May 8, 2025

Re: Line P(2<sup>nd</sup>) (30" Steel Gas Pipeline) and Line P(South) (20" Steel Gas Pipeline), Atmos Energy Pipeline and the *SE LOOP PH2 PLAN AND PROFILE ATMOS GAS LONO EXHIBIT* for the proposed East Wilco Hwy Seg 2 Ph 1 Project, Williamson County, TX.

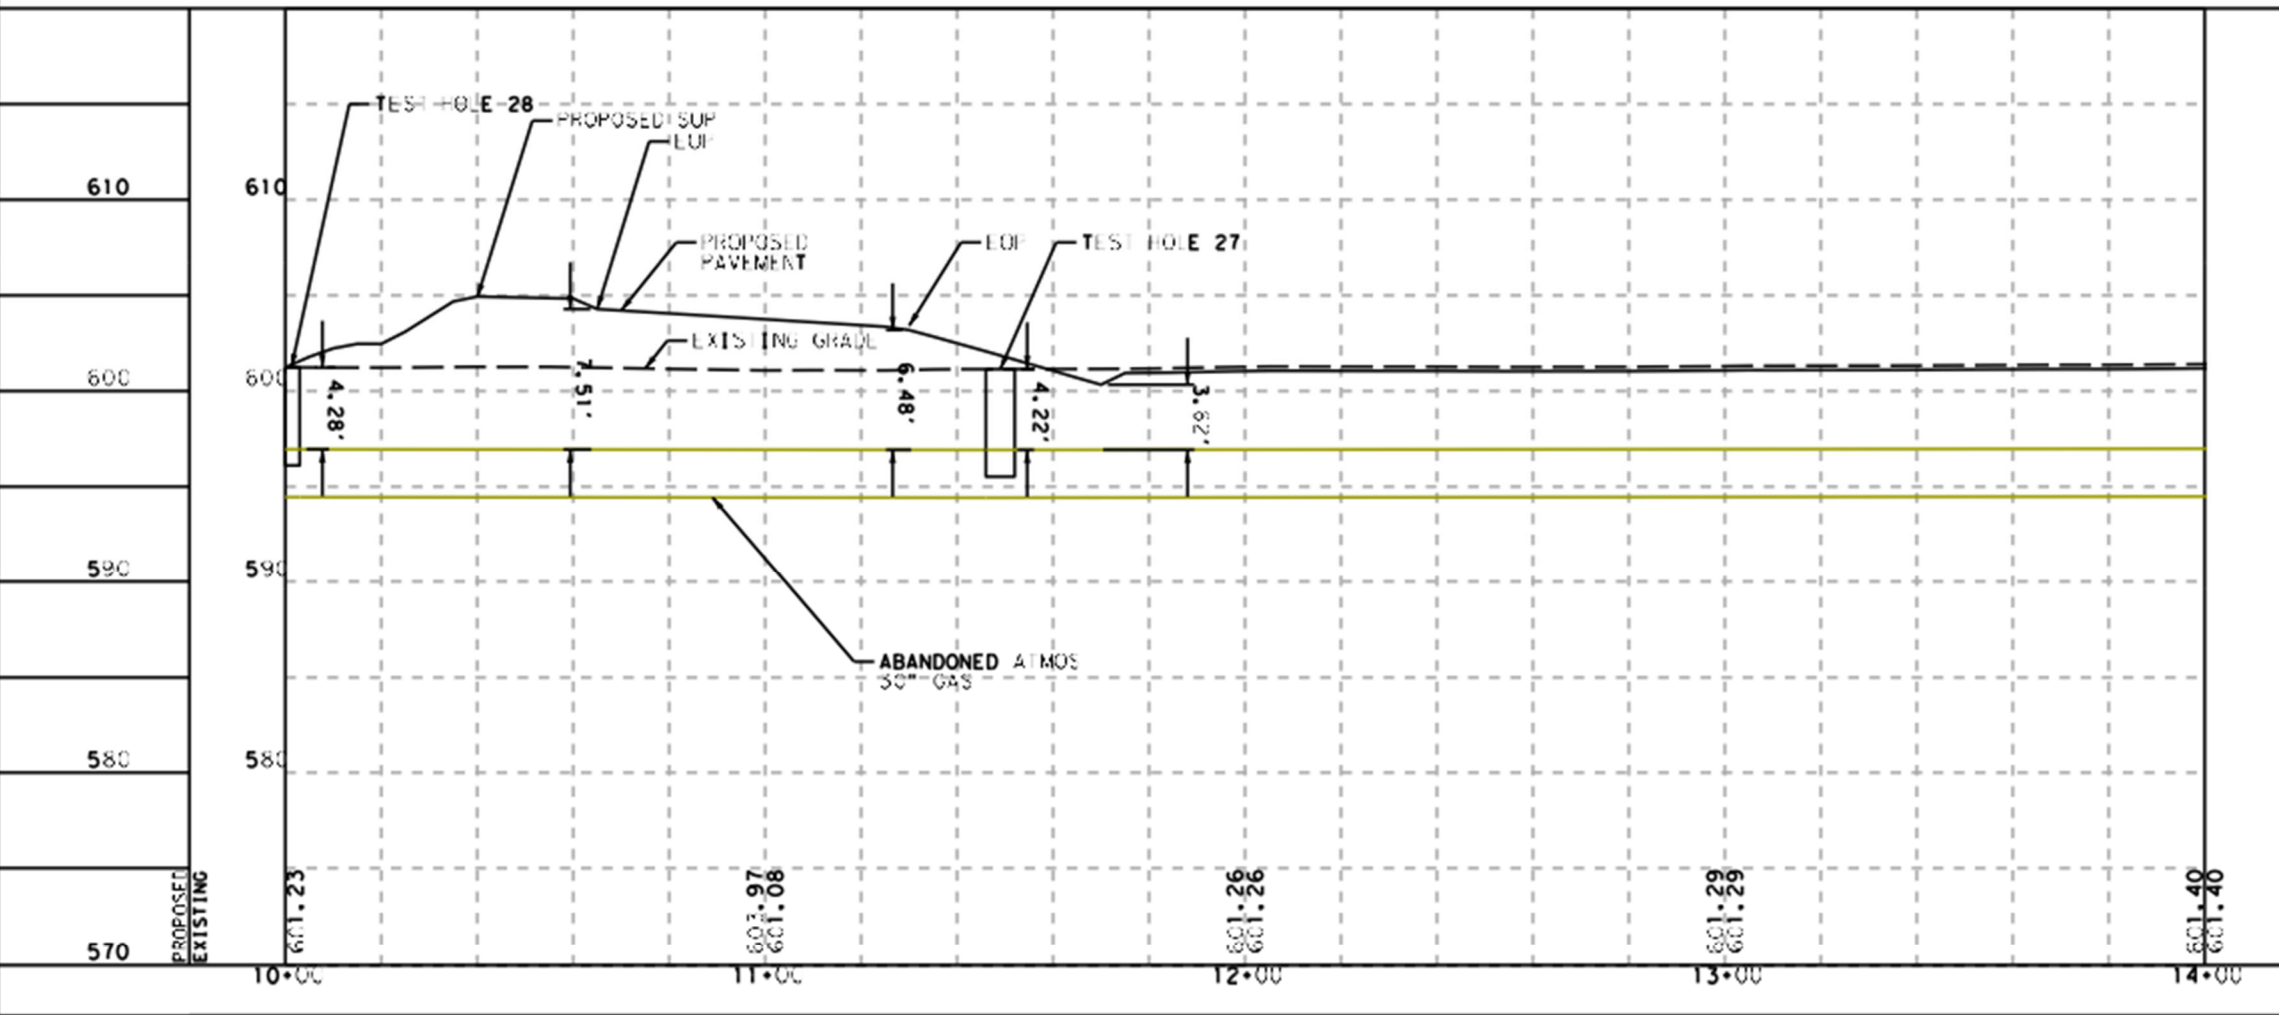
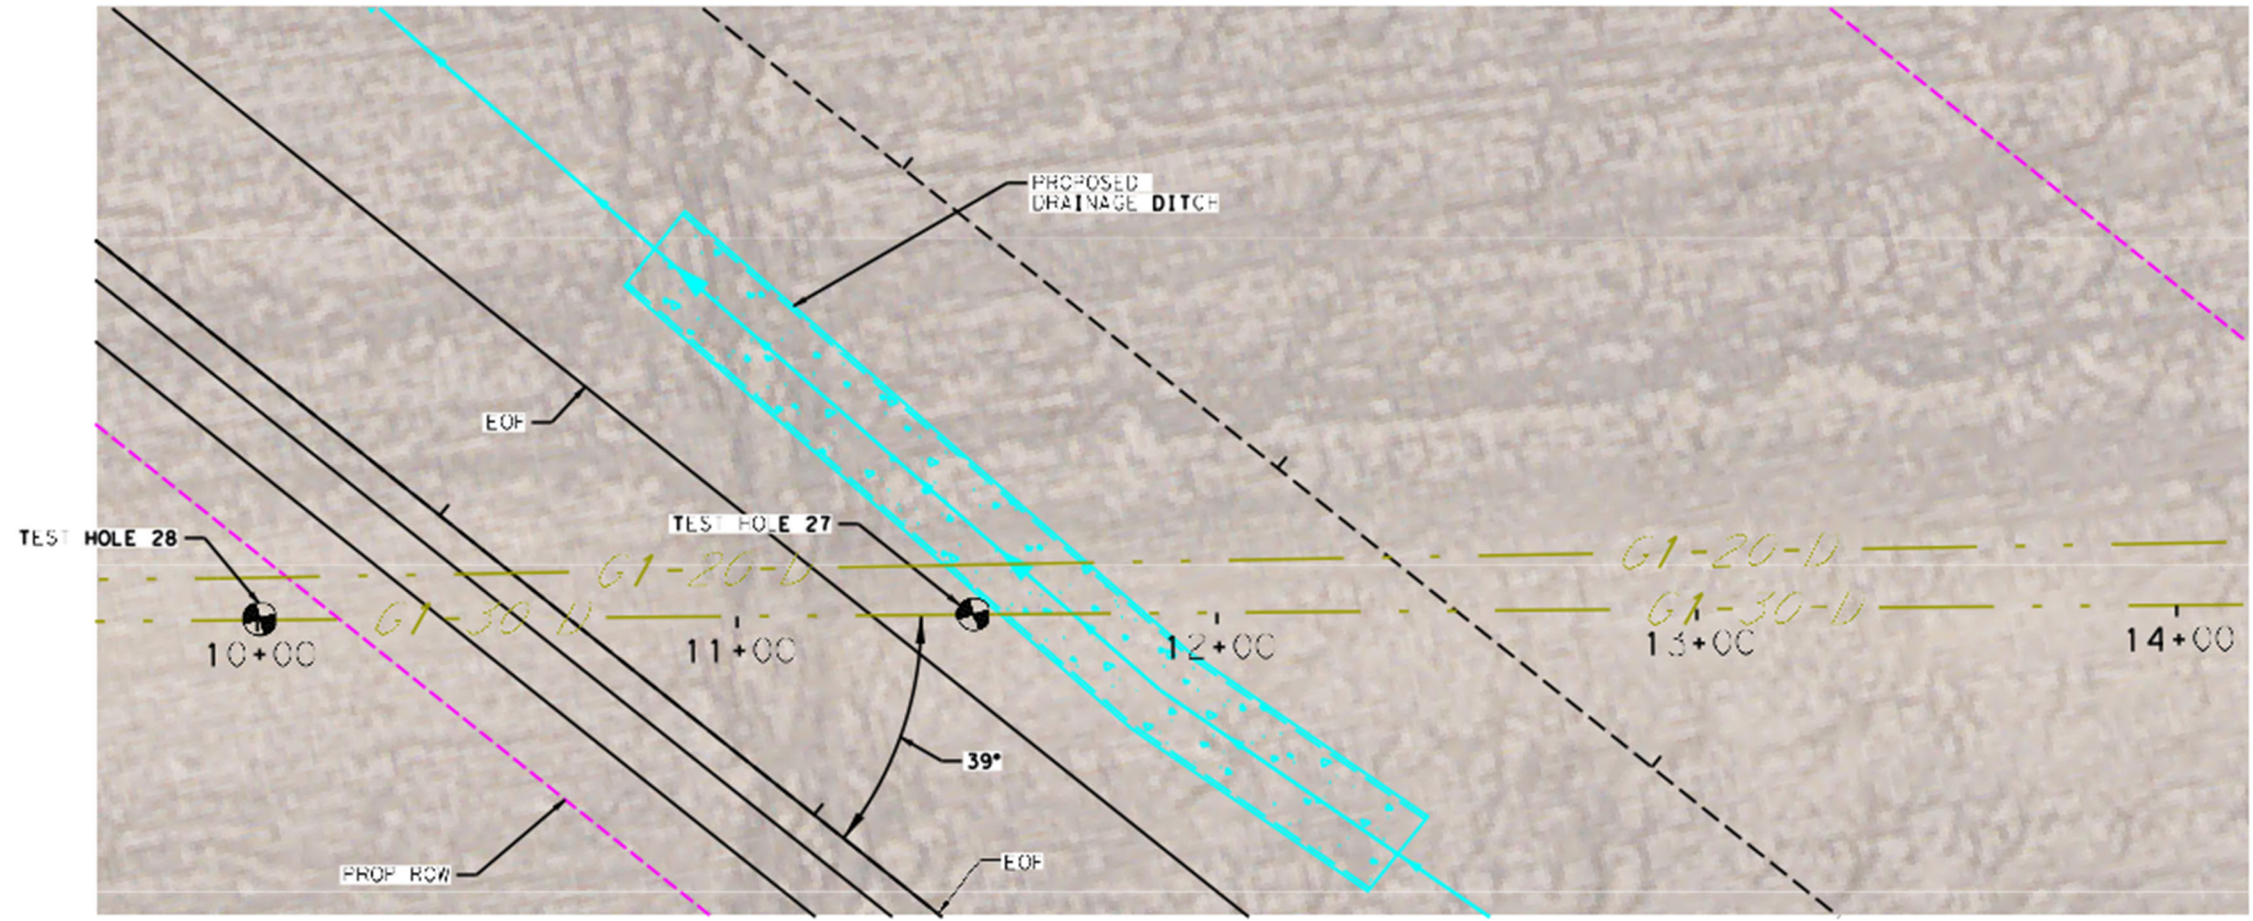
- Based on previously provided construction equipment loads and a stress analysis, a timber matting air-bridge per **Atmos Standard 11-100-00** shall be utilized for any construction equipment crossing prior to the installation of the above referenced road/street and protective slab. There must be an air gap over the designated crossing locations for the construction equipment to cross. *At no time shall construction equipment be allowed to travel parallel with the right-of-way, directly over the top of any Atmos pipeline*

- A minimum of **4.22 feet** for Atmos Energy's Line P(2<sup>nd</sup>) (30" Steel Gas Pipeline) and **3.38 feet** for Atmos Energy's Line P(South) (20" Steel Gas Pipeline) of existing cover shall be maintained over the existing Atmos Energy facilities where construction vehicle crossings will occur prior to the construction of the proposed roadway pavement improvements for Williamson County.

- No medium to large vibratory compaction equipment is allowed within a minimum of 10 feet from the pipeline(s). Only walk-behind vibratory rollers / compactors are allowed.
